From The Chairman,
c/o The Workhouse Museum
Allhallowgate,
Ripon, HG4 1LE
info@riponcivicsociety.org.uk
www.riponcivicsociety.org.uk

Planning Application ref. no: 20/03200/FULMAJ
Former North Yorkshire Timber premises, Trinity Lane, Ripon, HG4 2AL

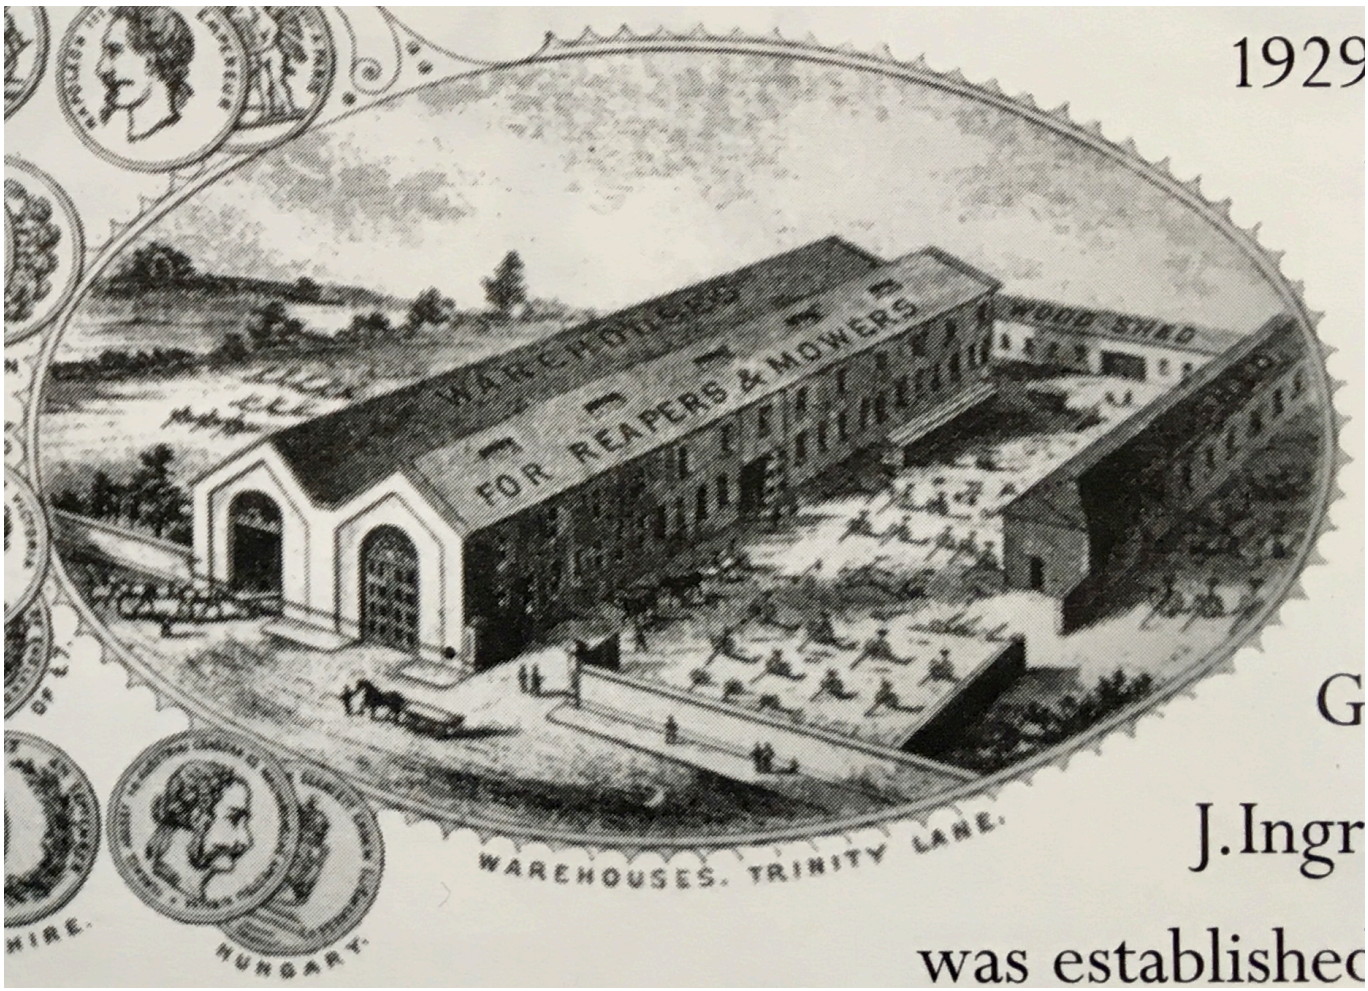
The site is within the Ripon Conservation Area. The building is not listed. We have read the Heritage Statement and find it extremely disappointing. The building is the warehouse of the former Kearsley metal manufacturing company, the office for which survives on North Street. Terraced housing surrounding the site includes dwellings but for Kearsley employees. The attached illustration explains this information.

As such it is an important survival of Ripon's industrial heritage and its importance is underestimated and in this application totally overlooked. The Society contends that the building clearly constitutes an undesignated heritage asset deserving every effort to secure its retention and conservation.
